AUTO ALLIANCE

Re: Comments to CARB Proposed 2018 Improvements to Vapor Recovery Nozzle and Vehicle Fill Pipe Specifications

Figure 1

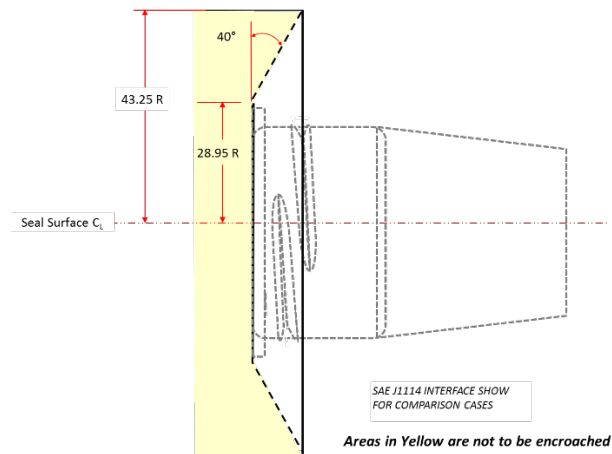
- Figure A needs clarity on the definition of the zone.
 - With the current figure if tapered zone starts at, for example, 52.0mm seal surface, the 40° clearance zone would end before reaching the 86mm outer range, and is not defined.
- The Alliance proposes replacing Figure A with Figure 1 below.
 - This establishes a fixed zone for the nozzle bellows referenced in CARB TP-206.
 - Fixing the zone allows for the clearance and relevance to spherical, conical, and planar nozzle boots.
